SOUTH BAY BRIDGE
S.H. 9113, WHITEHALL-DRESDEN
Route 22
WASHINGTON COUNTY

FIELD CHANGE SHEET

SHEET 26-F1 SUPERCEDES SHEET NO. 26
DUE TO THE FOLLOWING REASONS:

PLANS FOR RECONSTRUCTING WITH FEDERAL AID, A PORTION OF THE
WHITEHALL - DRESDEN CENTER, PART 1, S.H. No. 5578
Between Station C 130+75 and Station C 148+60, a length of 0.33 mile in the Village of Whitehall
AND THE
SOUTH BAY BRIDGE, S.H. No. 9113
Between Station C 148+60 and Station C 163+00, a length of 0.27 mile of which 0.16 mile is in the
Town of Whitehall and 0.11 mile is in the Town of Dresden

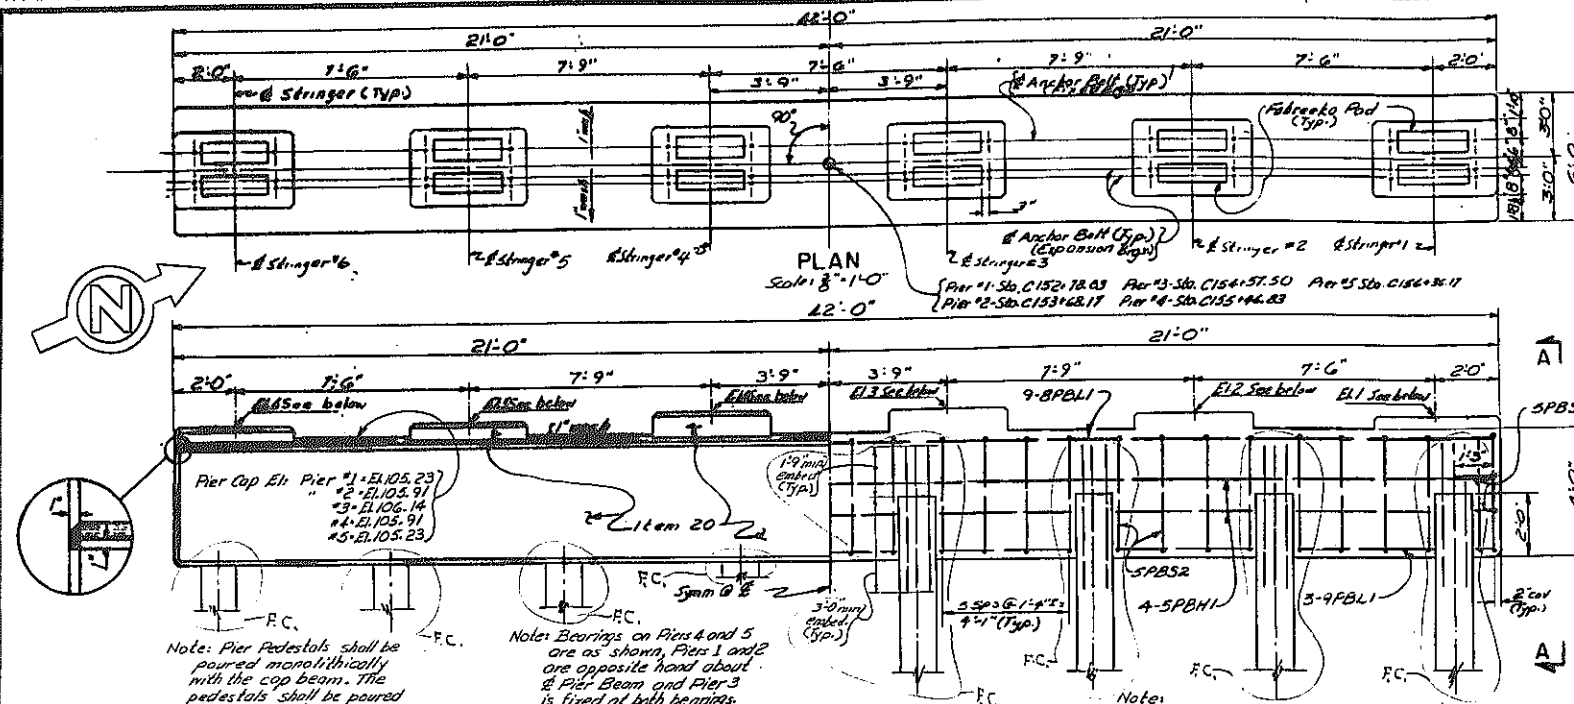
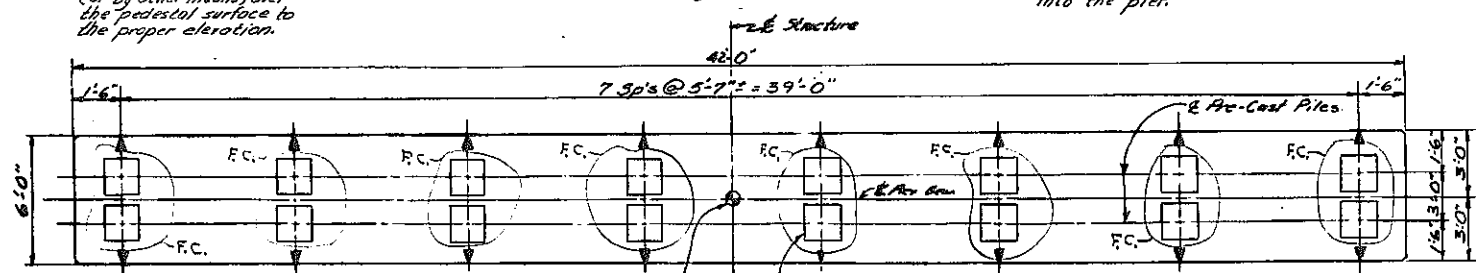
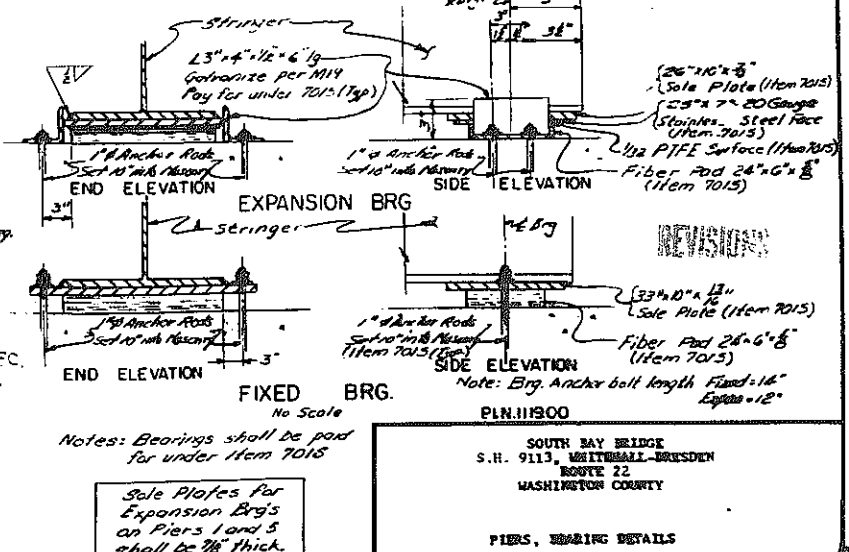
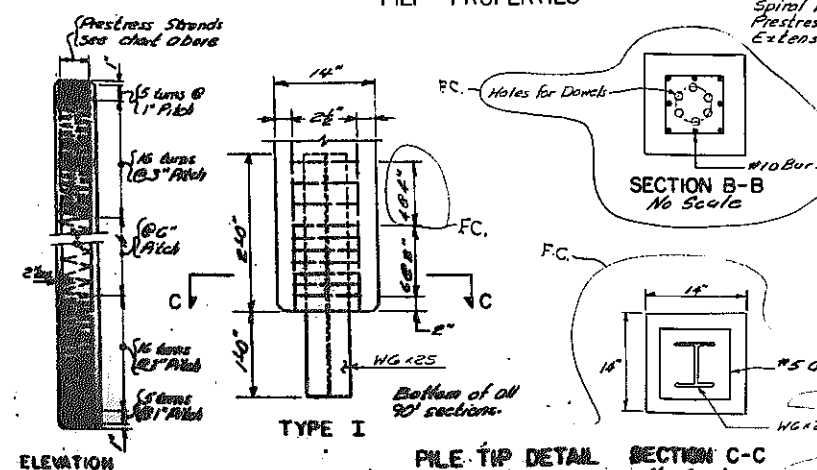
- The addition of GFSVI bar reinforcement in the top of the pile was due to their omission on the original contract plans.
- Change in pile section from octagonal to square.

ITEM	DESCRIPTION	UNIT	INCREASE	NET CHGE
2B	Bar Reinforcement for Stc	LB's	3425	+3425

SOUTH BAY BRIDGE
 S.H. 9113, WHITEHALL - DRESDEN
 ROUTE 22
 WASHINGTON COUNTY
 RAILING DETAILS

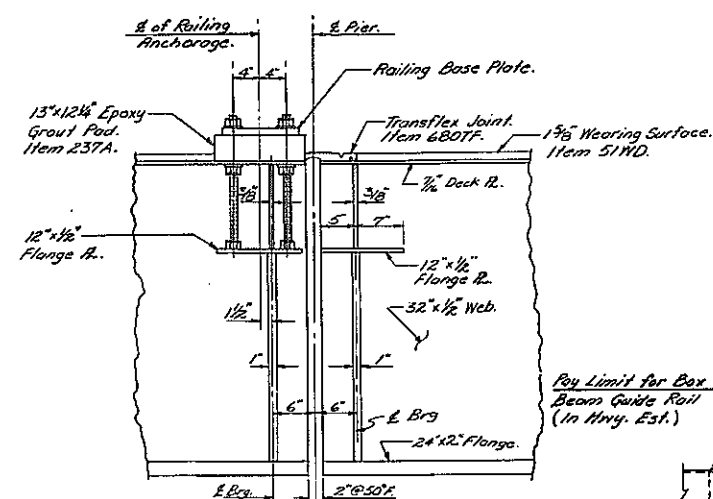
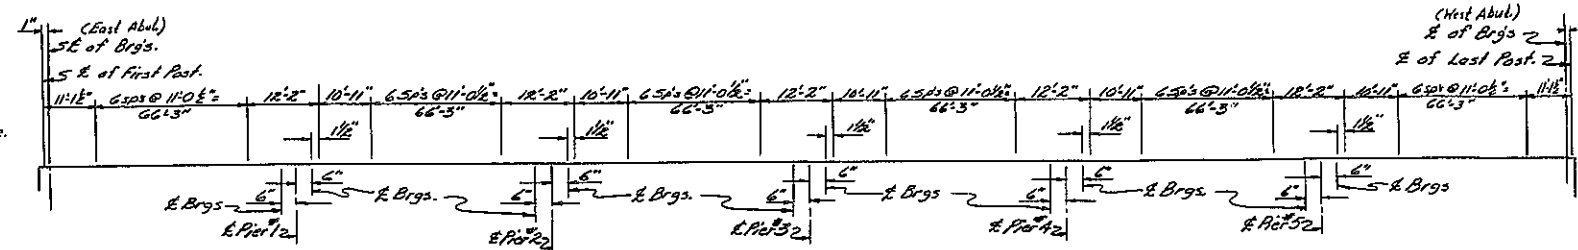
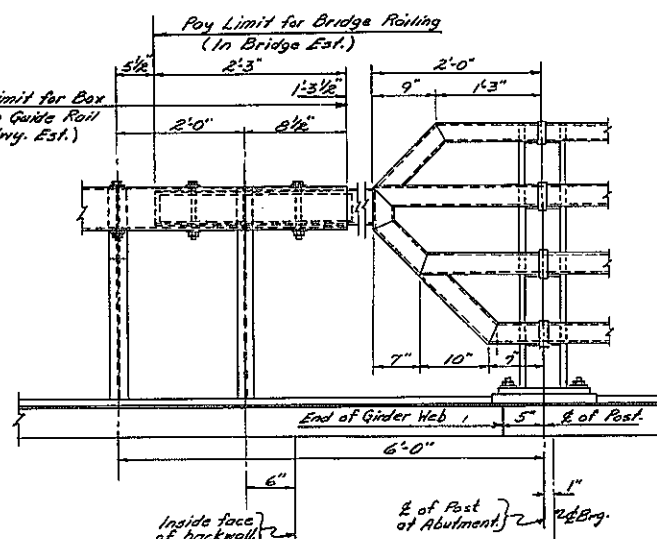
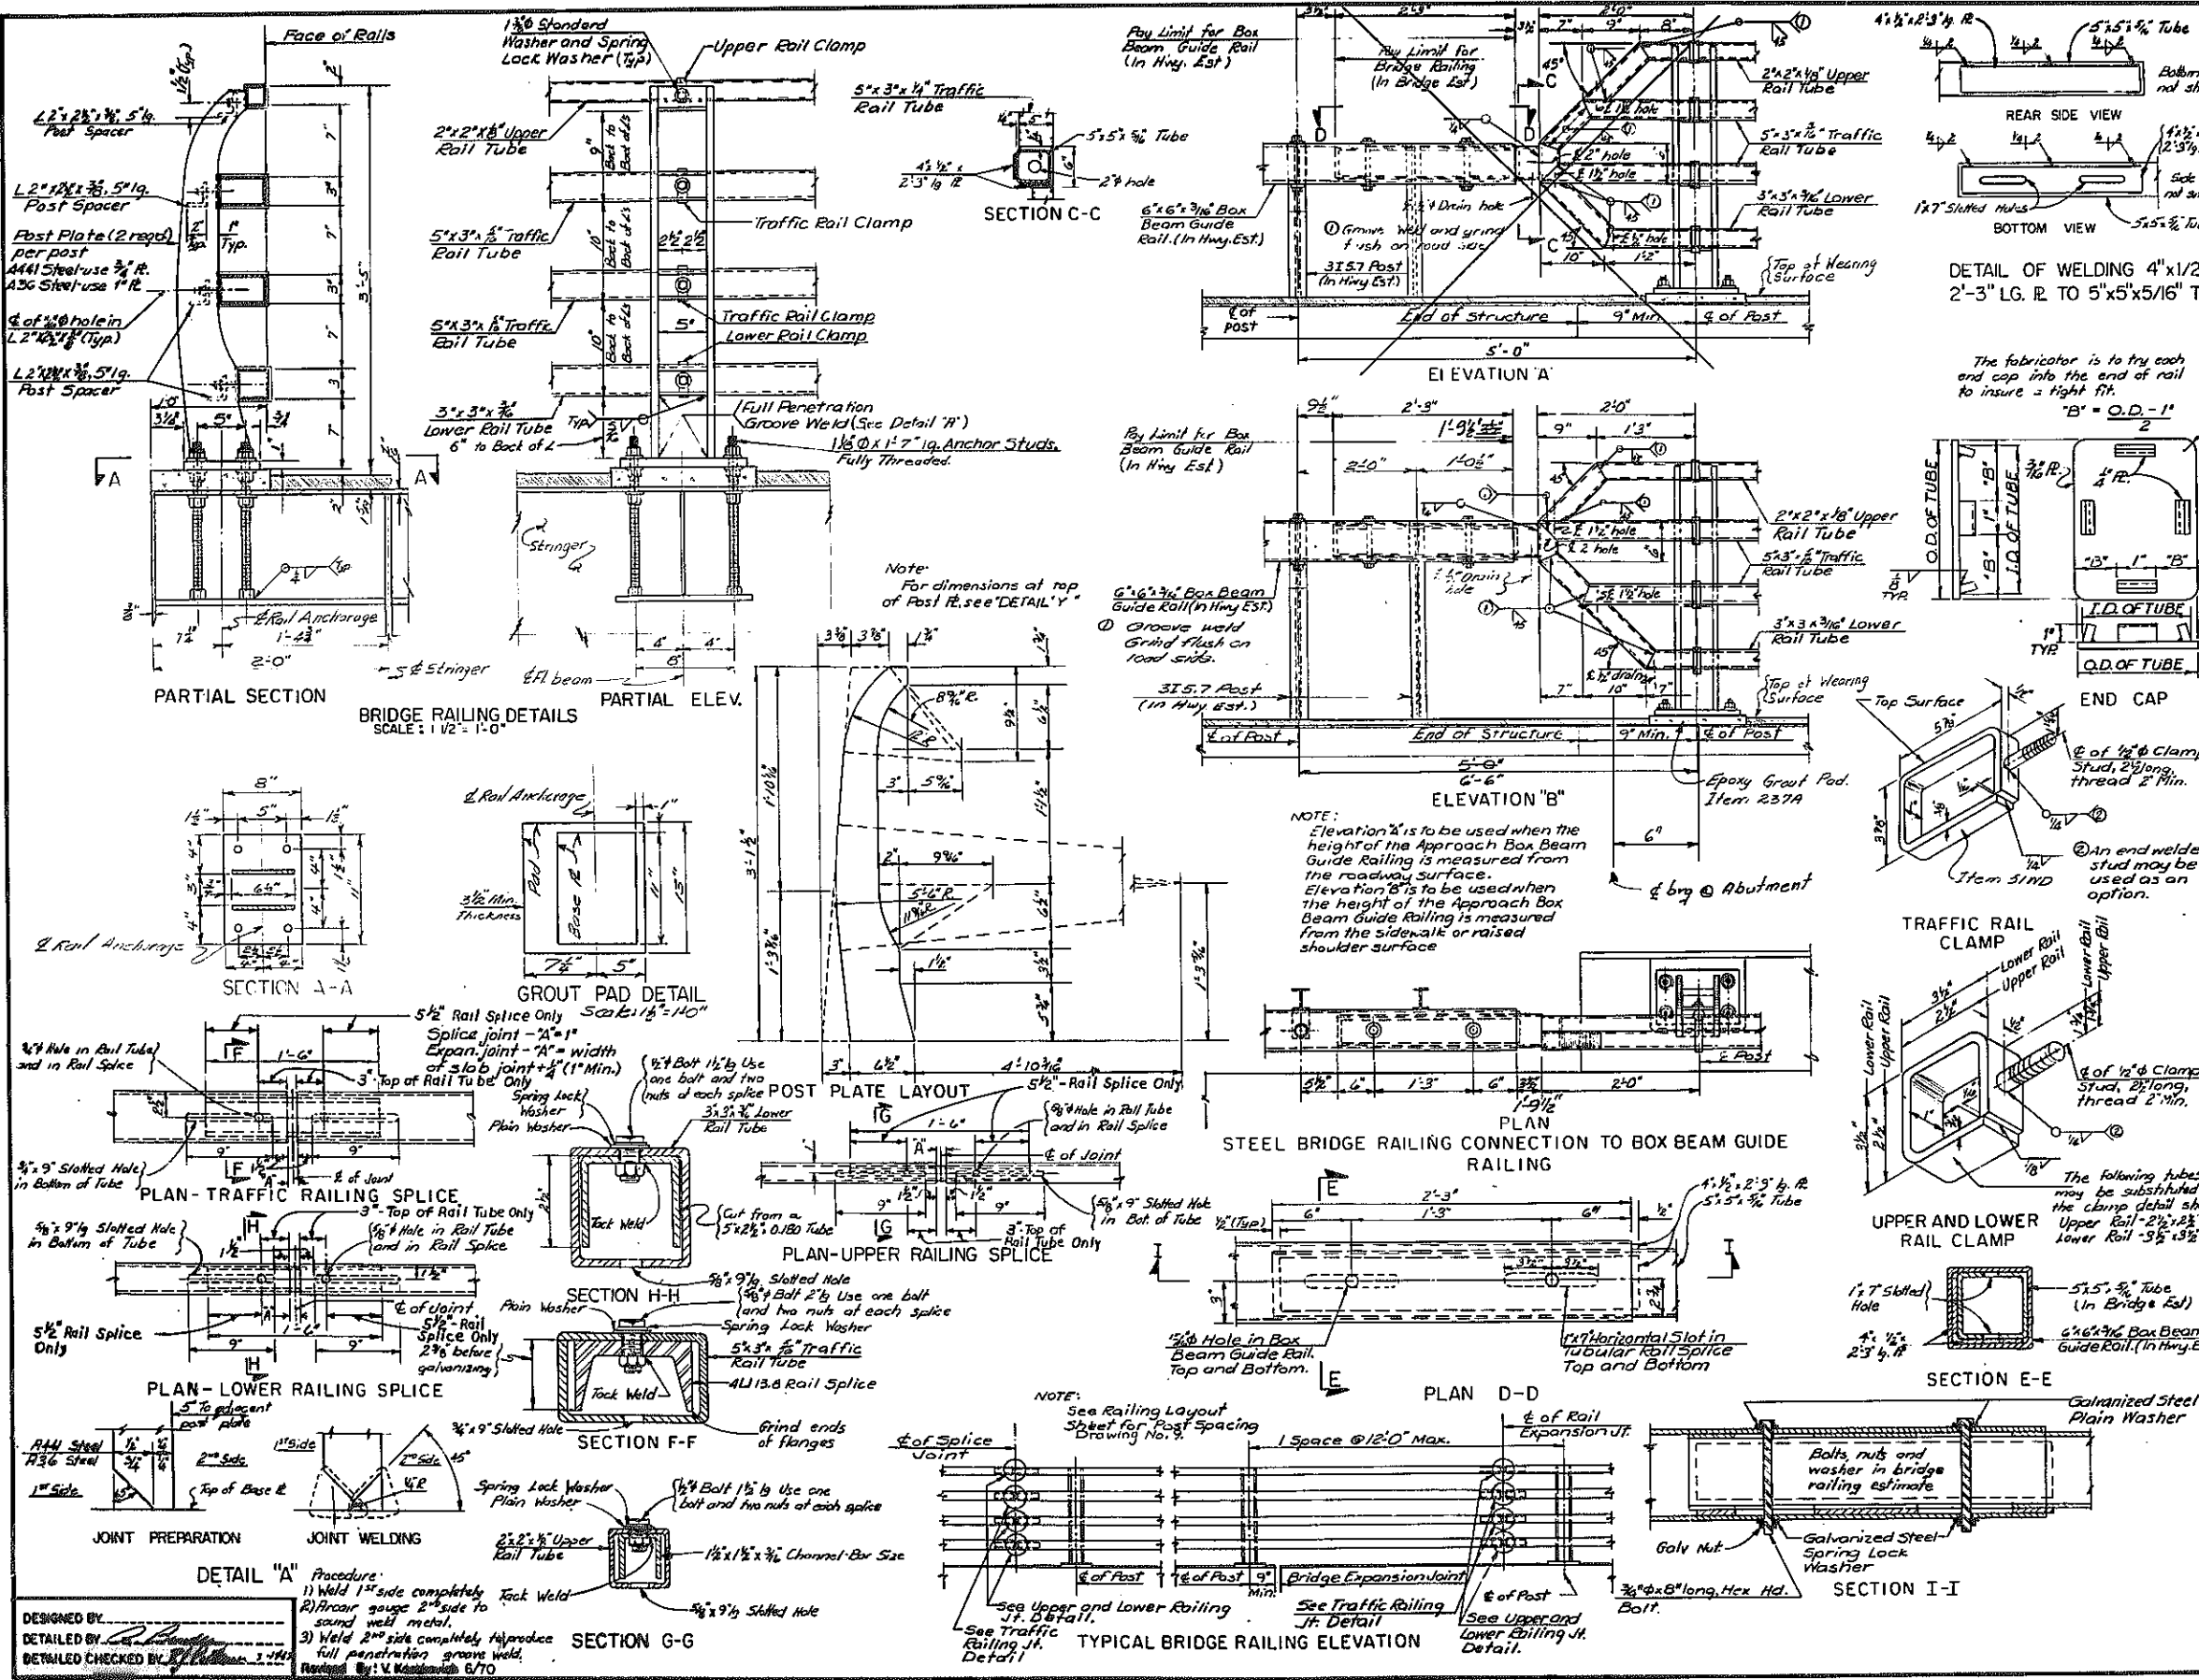
CHANGE IN QUANTITIES					
ITEM	DESCRIPTION	UNIT	INCREASE	DECREASE	NET CHGE
680TF	Transflex Expansion Joint	L.F.	0	10	-10

NOTE: This sheet does not supersede sheet 30, it is a supplement to sheet 30.

FIELD CHANGE SHEET

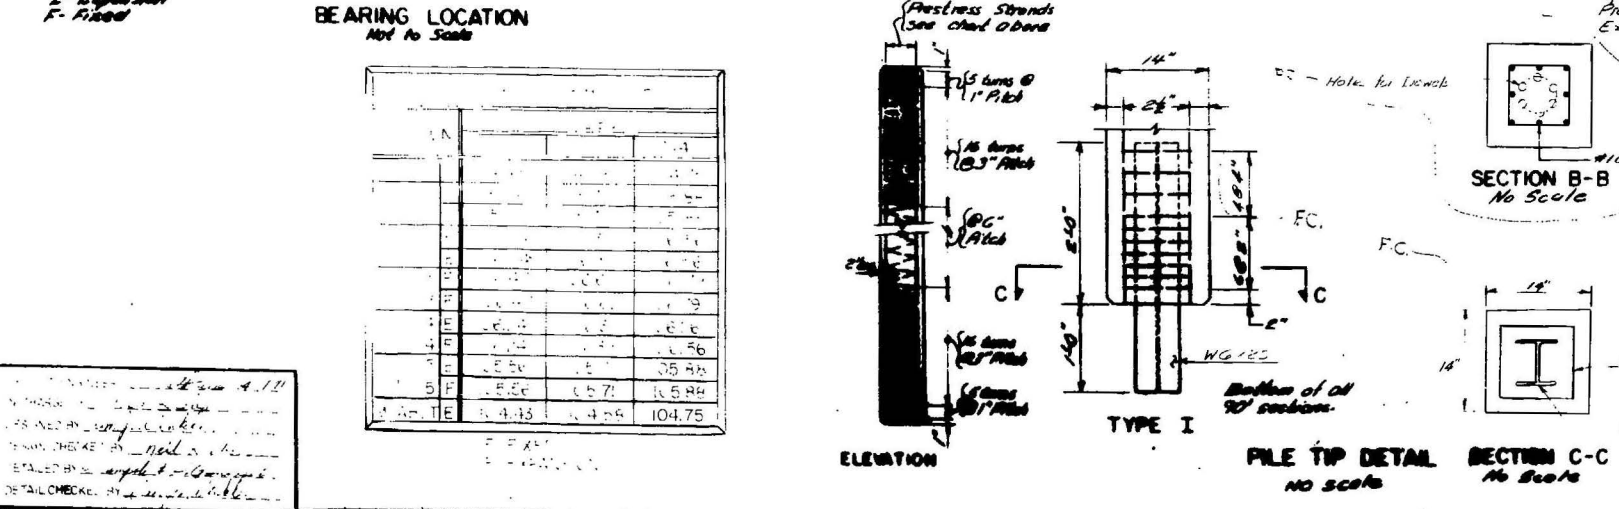
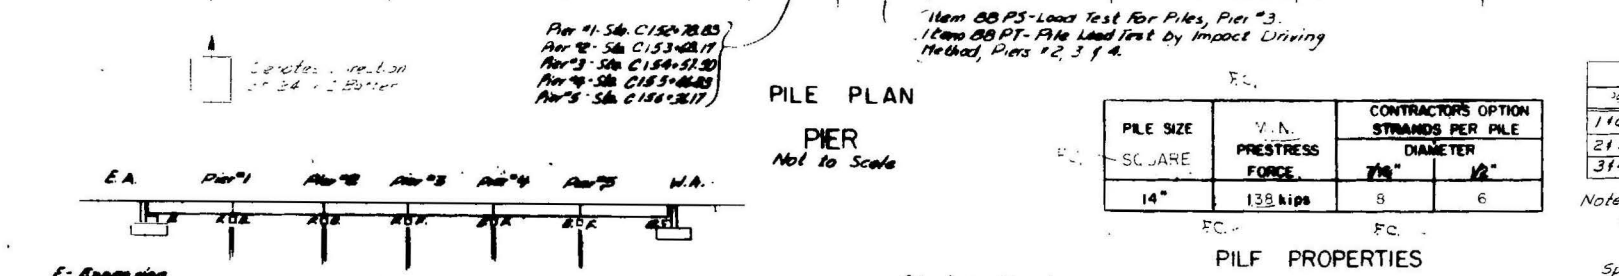
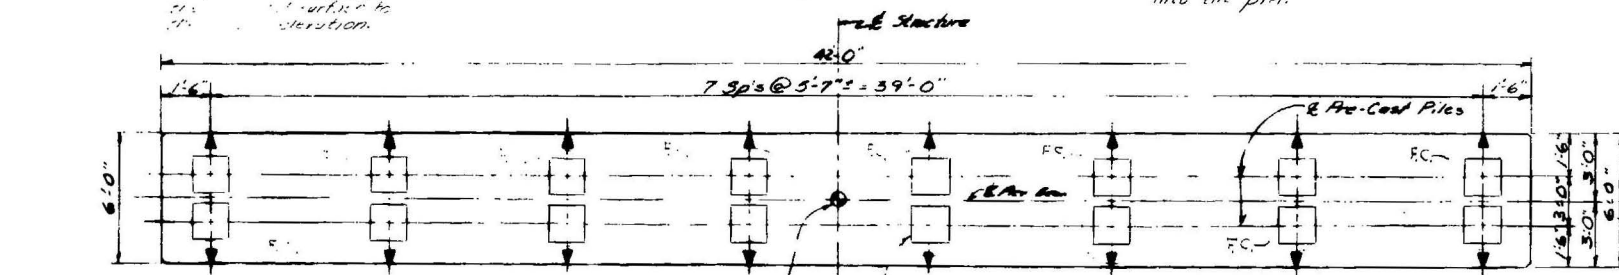
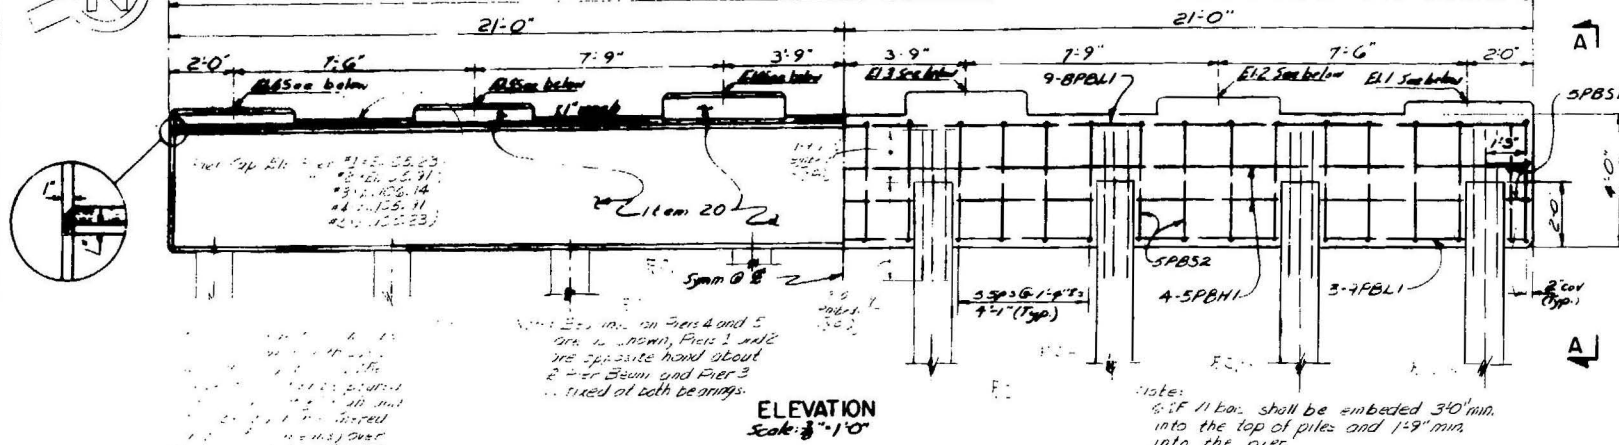
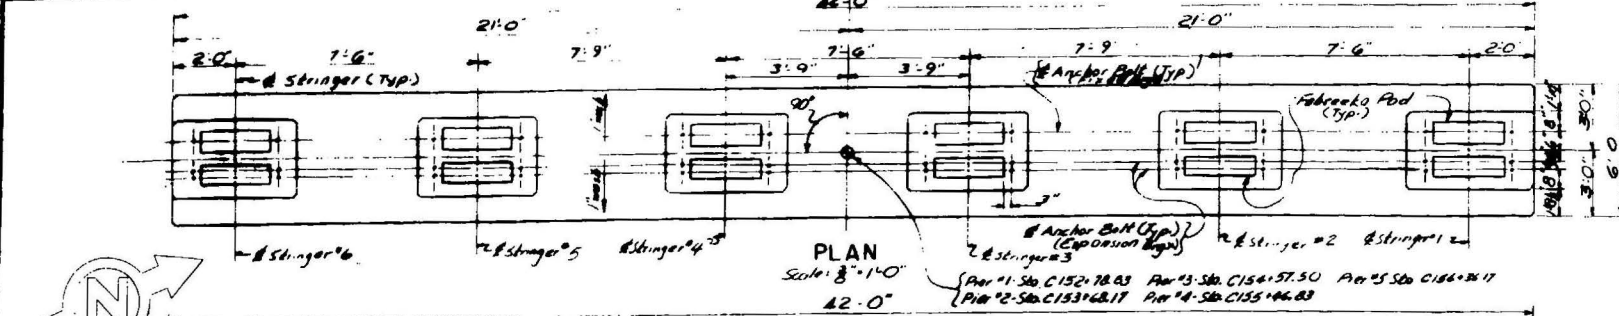
SHEET 26-A SUPERCEDES SHEET NO. 26
DUE TO THE FOLLOWING REASONS:

- The addition of 2" F501 bar reinforcement in the top of the pile was due to the omission on the original notes & plan.
-

CHANGE IN QUANTITIES				
ITEM	DESCRIPTION	UNIT	INCREASE	NET CHGE
28	Bar Reinforcement for Struct.	LB's	3425	+3425
